PROJECT: Land to the north-west of Westhide, Herefordshire, HR1 3RQ (Ref: P214619/F)

Landscape and Visual Impact Assessment Addendum: Amendments to Landscape Proposals

This addendum provides an update on landscape and visual matters in respect of amendments made to the Masterplan and Landscape Mitigation and Enhancement Plans submitted with the planning application (Ref: P214619/F). It is in response to comments from the Landscape Officer, Tree Officer and Ecology Officer at Herefordshire Council.

Drawing Number:
3352_L_GA_00_01

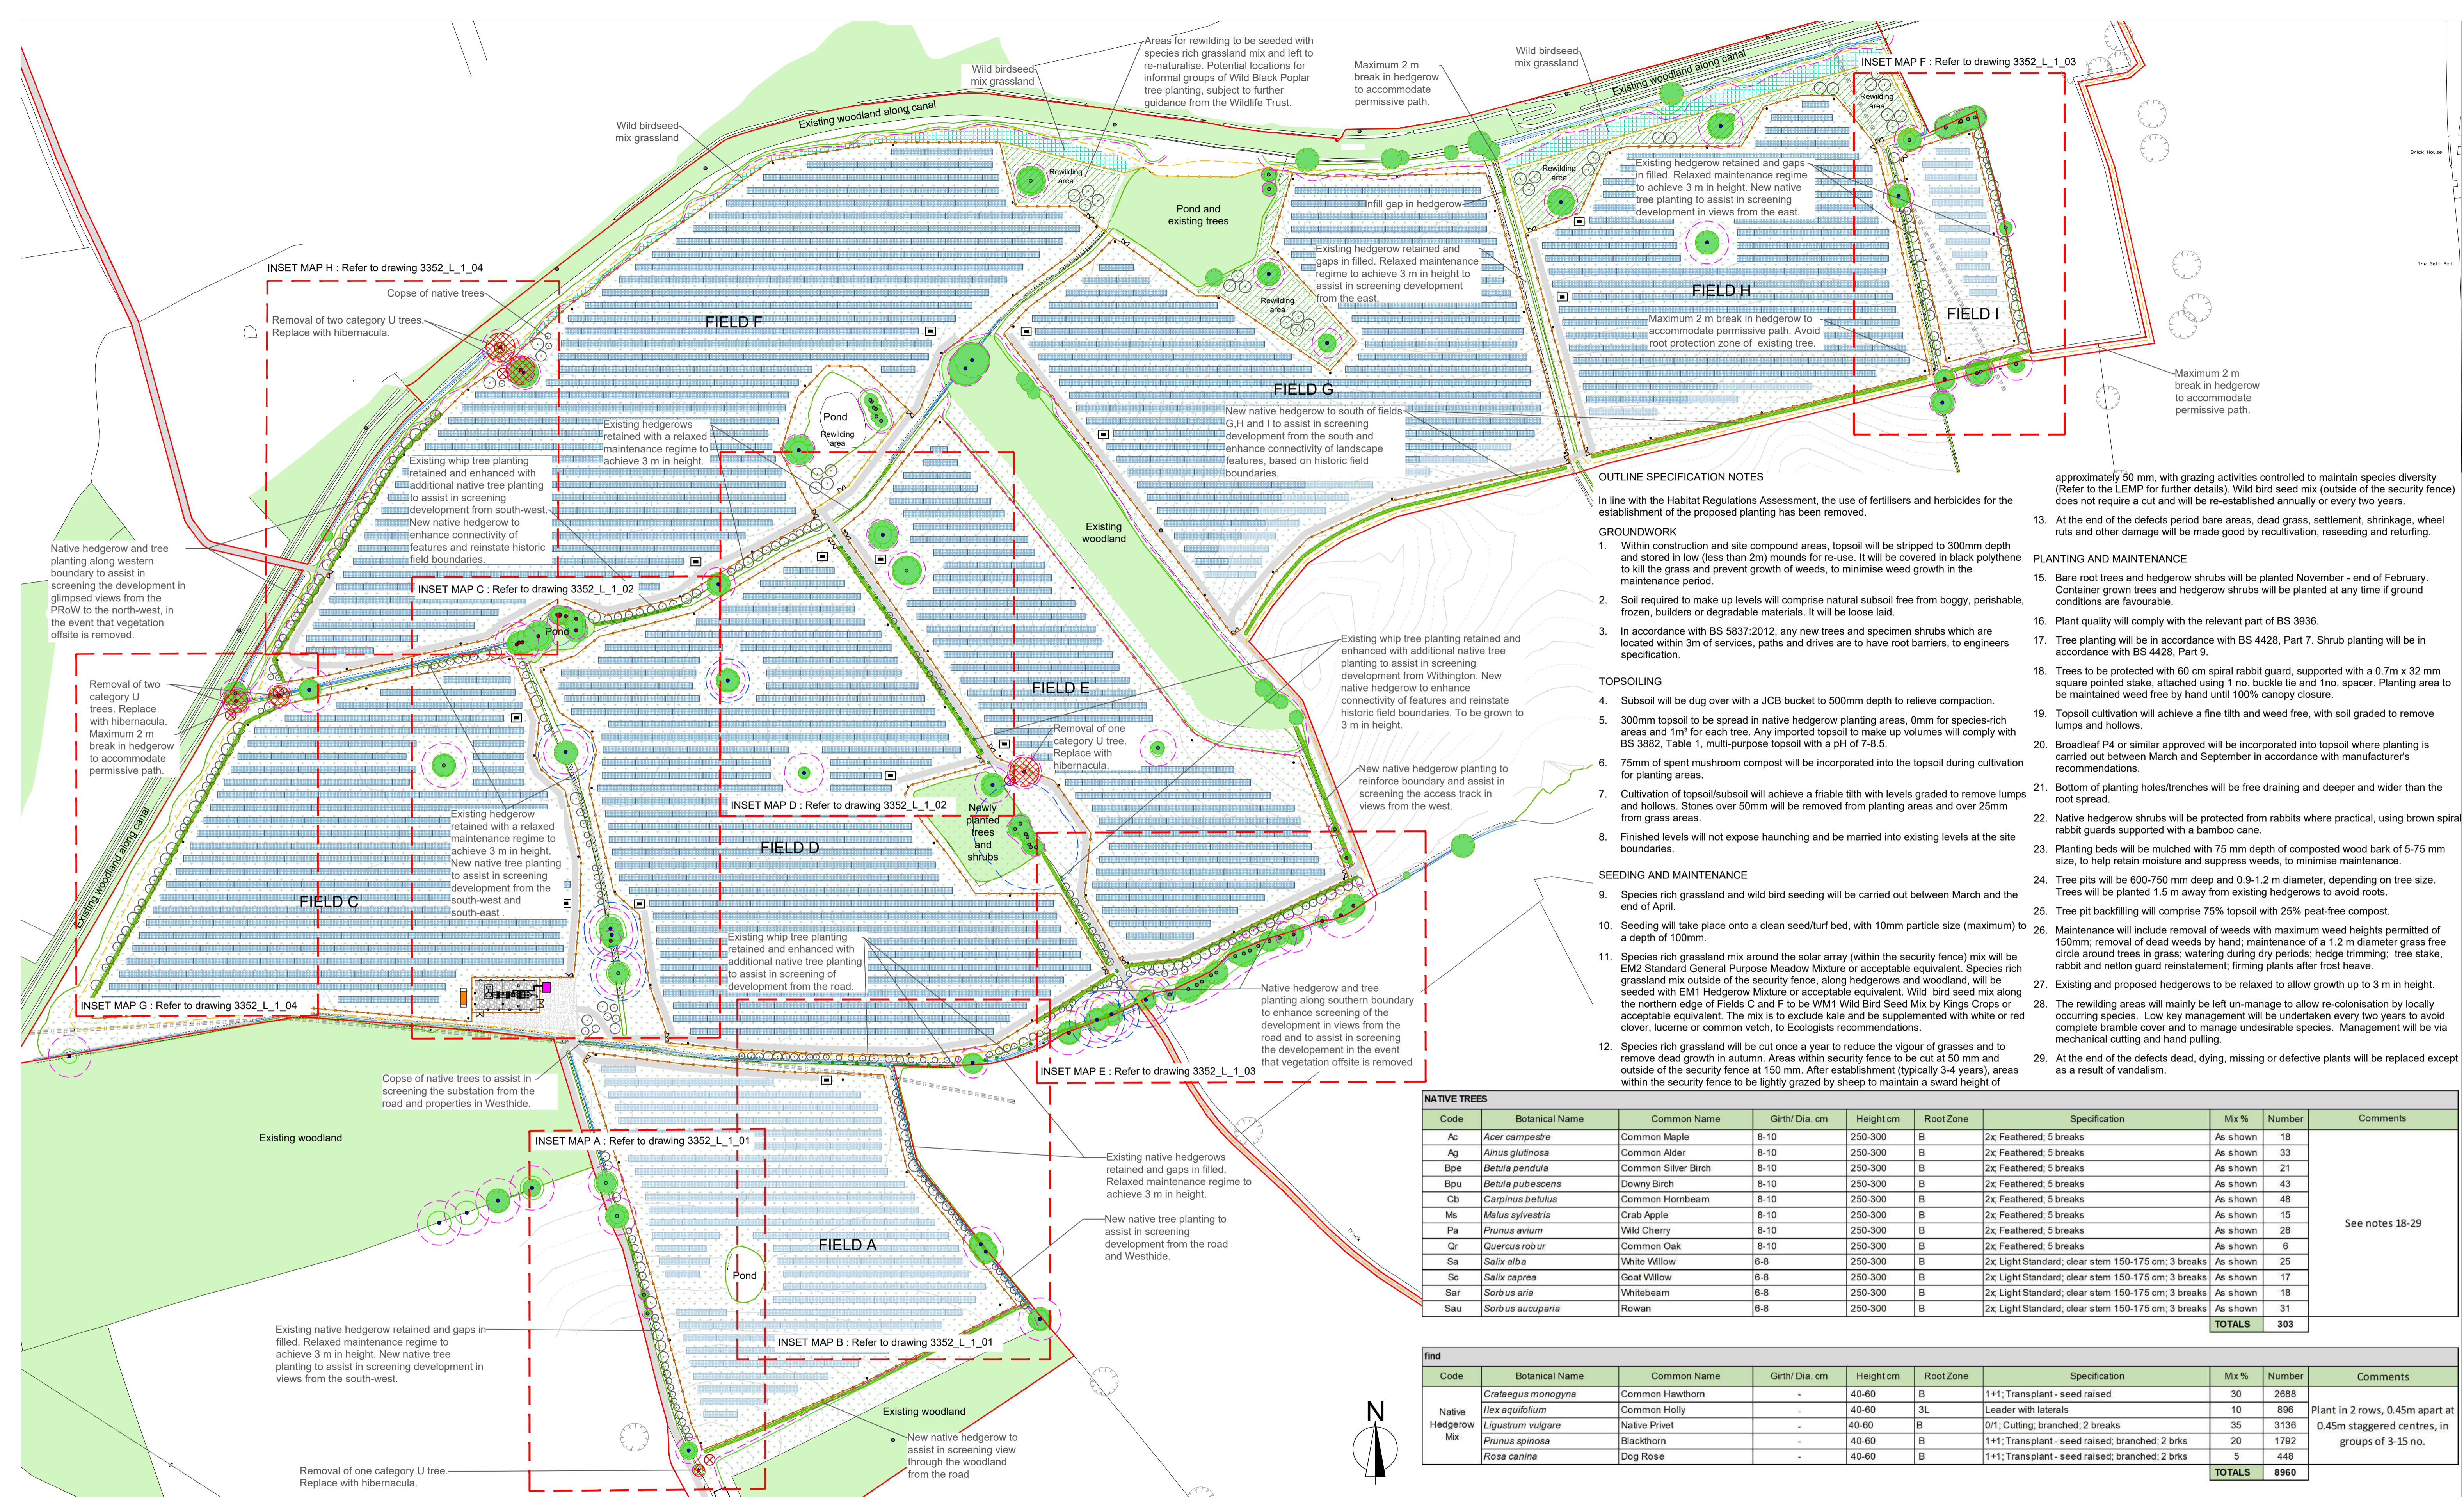
- *'Relocate substation to protect and give space for important trees.'*

The substation has been repositioned further to the west to sit behind the existing woodland to provide more space for the nearby veteran Wild Black Poplars, as per the mark up from the Landscape Officer. A larger group of trees has been introduced to the east of the substation to provide additional screening of the substation in views from the road (refer to Viewpoint 2) and to respond to the comment that *'there should be larger groupings of trees within the site'*.

Rev.	Date:	Description:	Drawn	Ch'd
A	21/09/2021	Ecology and landscape additions as per comments	GS	JH
B	04/10/2021	Site access and permitted path amended as per comments	GS	JH
C	07/11/2021	Contours added	GS	JH
D	16/11/2021	Substation relocated and redline boundary updated. Minor amendments as per comments	JH	AS
E	18/11/2021	Redline boundary update	JH	AS
F	23/11/2021	Redline boundary update	JH	AS
G	14/06/2022	Updates as per local authority comments	JH	AS
H	20/06/2022	Minor amendments as per comments	JH	AS
I	23/06/2022	Amendments to GCN corridor	JH	AS

Status: PLANNING	Drawn: JH	Checked: LF
Scale: 1:2000@A1	Date: 03.12.2021	Approved: AS
Drawing Number: 3352_L_GA_0_02		Rev: D

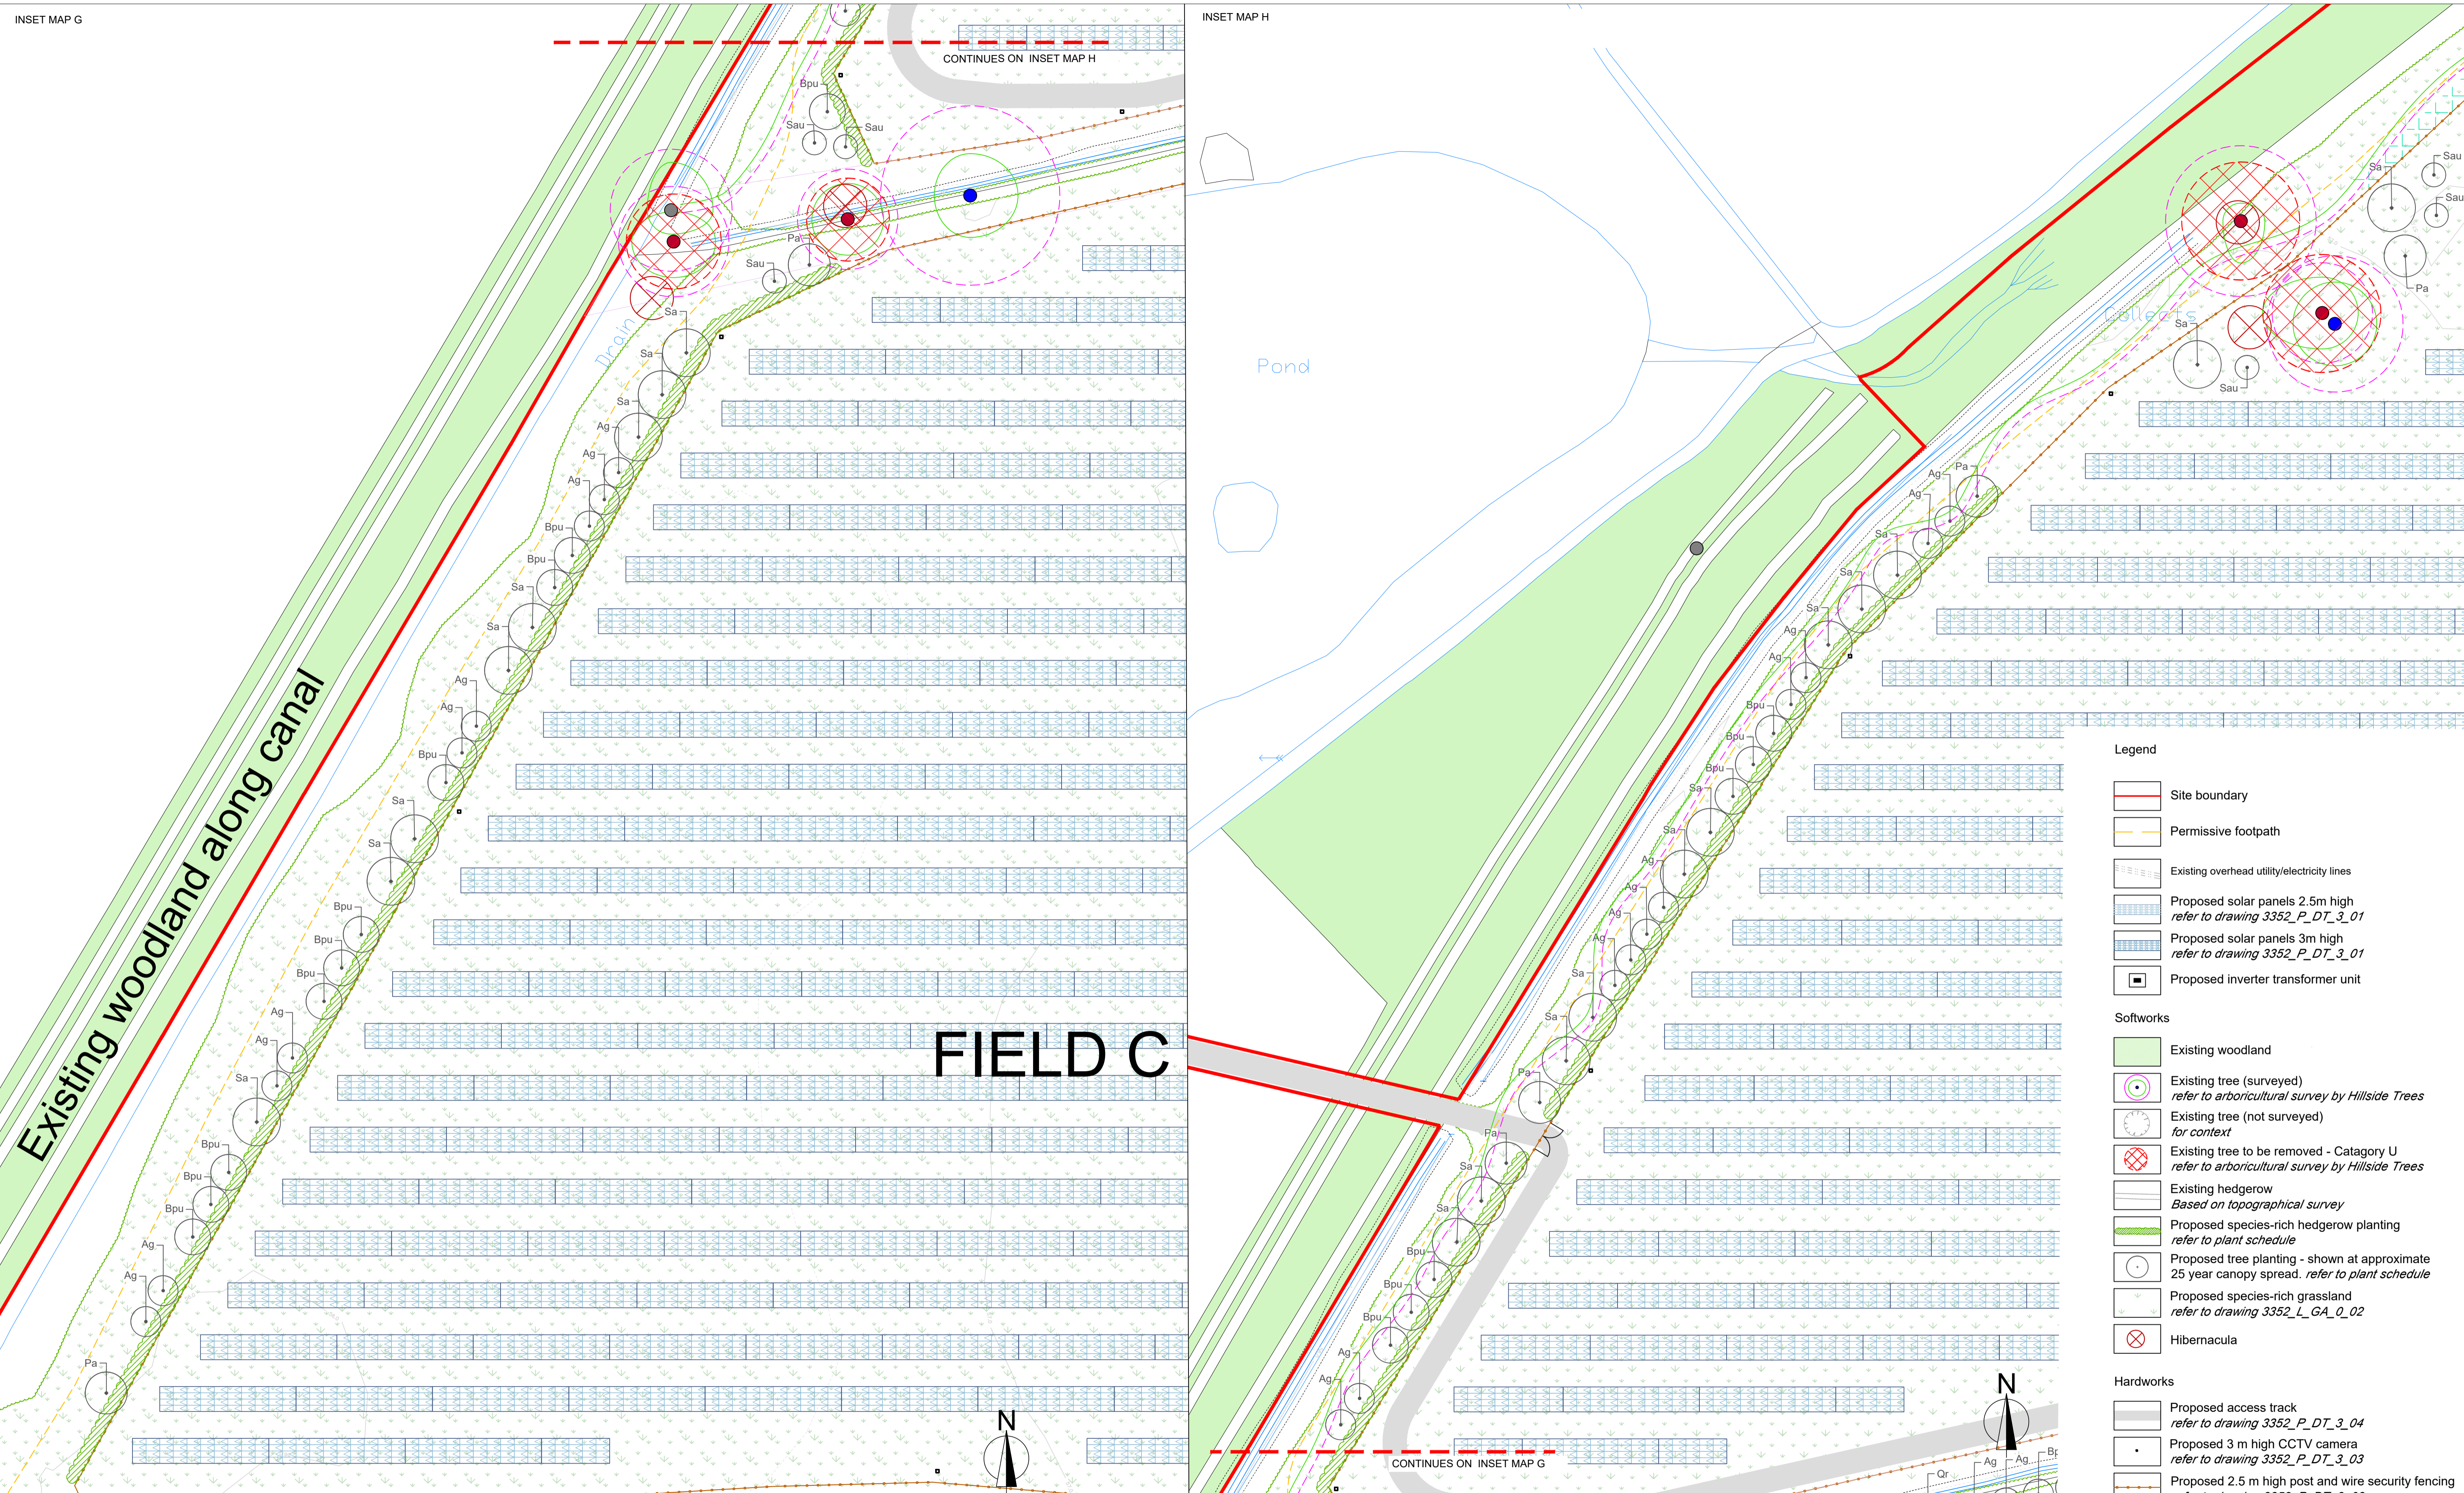
- *‘Review views looking onto the site and establish if the mitigation is relying on existing trees and vegetation that is outside of the site boundary, and determine what the impact would be if this would be removed. The intent is to ensure that all mitigation is achievable as part of the development.’*

- *'Go beyond actual root protection areas to respect what could be considered a reasonable distance for the solar panels to be away from the tree';*
- *'Ensure substantial protective zones around all Black Poplar, and all important trees is provided';*
- *'Protect existing tree roots from footings, vehicles and infrastructure.'; and*

- *'Give trees adequate space and aim to maintain well defined landscape areas, that can be fenced planted with trees and 'rewilded'; and*
- *'Remove solar panels to create the opportunity to create one single large habitat area. The reduction of solar panels is minor, compared to the opportunity to make a lasting woodland or 'rewilding' area'.*

The positioning of panels around the existing trees across the site has been reviewed to ensure that they are a reasonable distance from the trees, going beyond the root protection areas (RPA) identified on the tree survey by Hillside Trees. Access tracks, where possible, have also been realigned to avoid RPAs. Any construction works within RPA to be of no dig construction, as specified in the Arboricultural Report by Hillside Trees Ltd (December 2021).

Around the ancient and veteran trees identified by the Woodland Trust an increased buffer of 15 times the diameter of the tree was used, as requested by the Tree Officer (T1, T2, T3, T23, G24, T26, T28 and G62 on the Tree Survey by Hillside Trees). The position of the solar panels, access roads and fence lines have all been amended to provide greater protective zones around these important trees.

Panels along the boundaries of Fields F, G and H have been removed to provide areas for rewilding which connects with existing habitat areas and isolated trees on the site, as per the mark up provided by the Landscape Officer. These areas will be secured by the previously proposed 2.4 m high timber post and wire fencing, along the boundaries of the solar panel areas, and a newly proposed 1.2 m high timber post and rail fence, along the edges adjacent to the proposed permissive path.

These areas will be sown with a species rich grassland mix, as per the wider development, with limited ongoing management to allow for the natural regeneration of these areas. It is proposed that these areas could be planted with new Native Black Poplars as part of a wider replanting of the species across the Westside Estate, as per the recommendations of the Tree Officer. This would be subject to further guidance from the Wildlife Trust.

Please note that the area of Wild Bird Seed Mix has been relocated from the western edge to this northern boundary alongside the rewilding areas. This is due to the overshadowing that would be create by the new native hedgerow and planting proposed along the western edge.

Rev.	Date:	Description:	Drawn	Ch'd
A	09/12/2021	Minor amendments	JH	AS
B	16/12/2021	Updated drawing notes	JH	AS
C	17/06/2022	Updated proposals to respond to comments from the local authority	JH	AS
D	23/06/2022	Updated specification notes - removal of fertilisers and herbicides	JH	AS
